KINGSTON FOSSIL PLANT (KIF) - ANNUAL FOSSIL ENGINEERING INSPECTION OF ASH DISPOSAL AREAS

KINGSTON FOSSIL PLANT- ANNUAL FOSSIL ENGINEERING INSPECTION OF ASH DISPOSAL AREAS

PICTURE 1- Wet, rutted area along Dike "C" should be repaired.

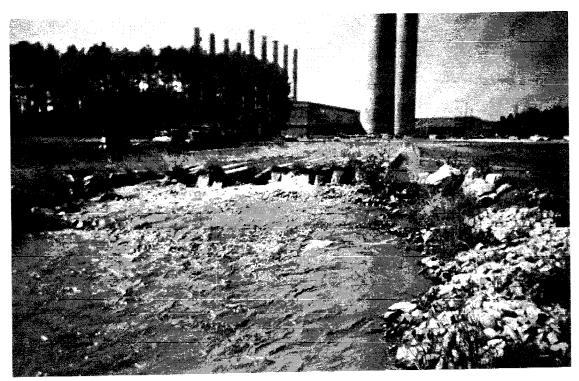
- 2.1 Dike "C" appears to be stable although there is one wet and rutting area.
  - 2.1.1 The exterior slopes have a good vegetative cover.
  - 2.1.2 There is a good gravel surface on the dike "C" roads.
  - 2.1.3 There is a 150' long area of rutting and standing water on the east side of the stilling pond dike. The ruts are up to 12" deep. (see 8.1) (picture 1)
  - 2.1.4 The inside of Dike "C" (east side and southeast corner of ash disposal area) is being eroded by wave action. (see 8.2)
  - 2.1.5 The concrete around the monitoring wells 5B and 5C along Dike "C" is cracked up. (see 8.3)
- 2.2 Seepage persists along the exterior slope of the southeast dike. The seepage is collected in an interceptor ditch and routed to an engineered wetland. The water is then pumped to the ash pond. Cattails and other aquatic growth continue to increase in the wetland.

- 8.1 Plant personnel should repair ruts and continue to monitor the exterior dike slopes for seepage, soft wet spots, animal burrowing, etc. and report any change to Fossil Engineering.

PICTURE 2- The ash sluice ditch should continue to be cleaned out and filled with earth liner and riprap or the rubber liner should be replaced.

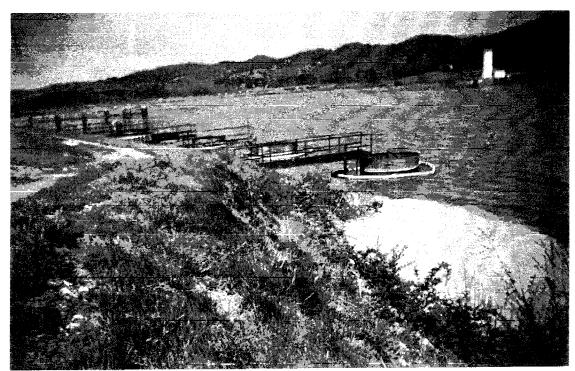
- 3.2 The fly ash continues to be sluiced into a rubber-lined ditch. The lining has deteriorated. Plant personnel have cleaned out the ditch and placed earth fill and riprap on the slopes for approximately 150 feet of the ash sluice ditch. (see 8.5) (picture 2)

- 7.4 Plant personnel have not replaced the rubber liner; only the first 150' of the fly ash discharge ditch has been replaced with rip rap. (see 8.5)
- 7.5 Plant personnel have added and monitored riprap at the outlet end of the existing dike storm drains. They have also added riprap to the inside of the stilling pool dike; however, waves continue to undercut the inside of the dike. (see 8.8)

- 8.4 Earthfill should be placed in gullies and eroded areas. The area should be graded and the disturbed areas shall be seeded and mulched.
- 8.5 Plant personnel should replace the rubber liner in the fly ash sluice ditch or continue to clean out the ditch and fill with earth liner and riprap as required.

PICTURE 4- Spillways and skimmers appear to be in good condition. There is some floating ash in the stilling pool.

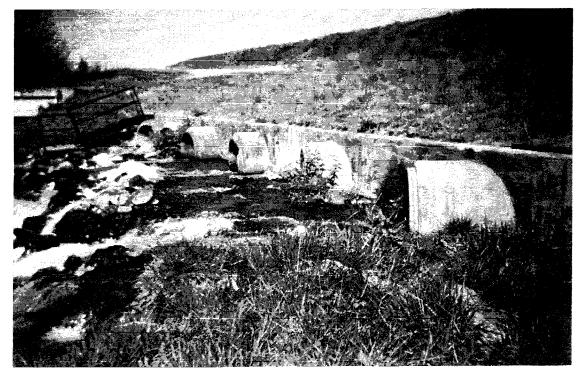
- 4.1 The plant constructed spillway and skimmer discharging water from the pond area into the stilling pool area appear to be in good condition.
- 4.2 There is some minor accumulation of floating ash in the southeast corner of the stilling pool. (see 8.6) (picture 4)

- 4.3 Five of the six standard spillways and skimmers in the stilling pool area appear to be in good condition and functioning properly. The spillway on the west end has been raised one section higher than the other five and is not discharging. (picture 4)
- 4.4 Five of the six outlet pipes were discharging at the time of this inspection and there was no visible loss of ash. The riprap appears to be in good condition at the spillway discharge outlets. (picture 5)

- 8.6 Plant personnel should periodically skim floating ash out of the stilling pond.
- 8.7 Plant personnel should rework the ditch in the coal yard to allow the ponded water to drain into the coal yard runoff pond.
